भू-गर्भीय निरीक्षण आख्या ए0जी0- 287 / सड़क / पुल / समेखण / उत्तराखण्ड / गढ़वाल-2020

Geological Assessment of the alignment corridor proposed for the
construction of 10.40 km long motor road joining village Purkul to
Bhirtali-Kimadi motor road, in Sahaspur block, distt. Dehradun.

03 फरवरी 2020

Digital map of the proposed alignment of village Purkul to Bitharli-Kimadi motor road, distt. Dehradun

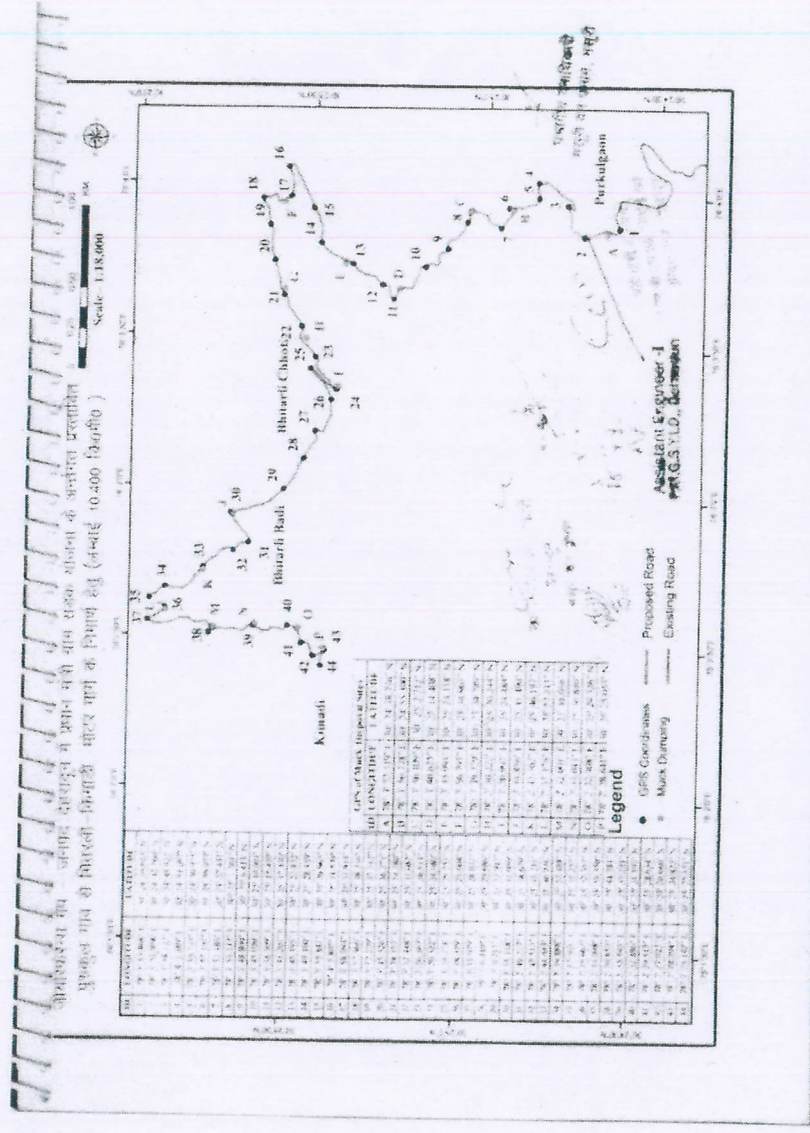
Due to the existing narrow jeep road(point no. 25 in digital map shown below) and a stretch of steep hill slope(point no. 11), the alignment 1 was questioned by the "Department of Forest and Climate Change". Therefore, on the request made by Er. Sanjay Singh, Executive Engineer, I carried out the geological assessment of the whole alignment with special focus on the "questioned stretch" of the alignment on 30.01.2020 in the presence of Er. S.B Lingwal, Assistant Engineer and Er. Vikas Barthwal, Junior Engineer, PMGSY, Irrigation Division, Dehradun.

The proposed 10.40 km long alignment corridor originating from km 6 of Malsi-Purkul motor road in the upslope direction comprising 5 HP bends following the upslope of the high gradient jeep road, in Sahaspur block, distt. Dehradun. The alignment stretch in questioned is the point no. 11 and 25 as shown in the digital map (explained in details below).

At the point no. 11 as per digital map, there is a small slip zone which activated recently before 2-3 years forming 2 chure. Prima Facie, it seems to be activated due to the continuous hydraulic impact at the toe of the hill slope as the gadera bears the sinous course with left bank as the cut-off side and right bank as slip-off side. The stretch of 40-50 m near point no. 11 passes across this steep slope have extensive seepage with fractured bedrock underneath. Therefore, toe protection is essential to avoid any toe erosion and facilitate sliding in future.

At the point no. 25, there is a existing jeep road but have gradient of 1:6 to 1:12 which is extremely high in comparison to the proposed gradient of 1:24 to 1:20. Also, the current jeep road passes across a slide zone which may become huge post toe-cutting. Therefore, the proposed alignment passing above the crown of the active slide zone.

1. Across the steep slope, i.e near point no. 11 in digital map, the construction for 50 m stretch of road should be carried out by half cut and half fill method with ascent upward. The extensive seepage will reduce the intergranular shearing strength and may facilitate sliding. Therefore, the slope with basement for gabion wall should be strength by deeply anchored soil nailing technique (for foundation) followed by shotcreting, so as to improve the ground characteristics and minimize the probability of any rock fall/sliding.

2. Due to the sinous course of the gadera, Gabion wall in 2-3 step should be construct at the toe of the hill slope point no. 11 (in digital map) to avoid toe scouring/erosion by the huge discharge of gadera in monsoon.
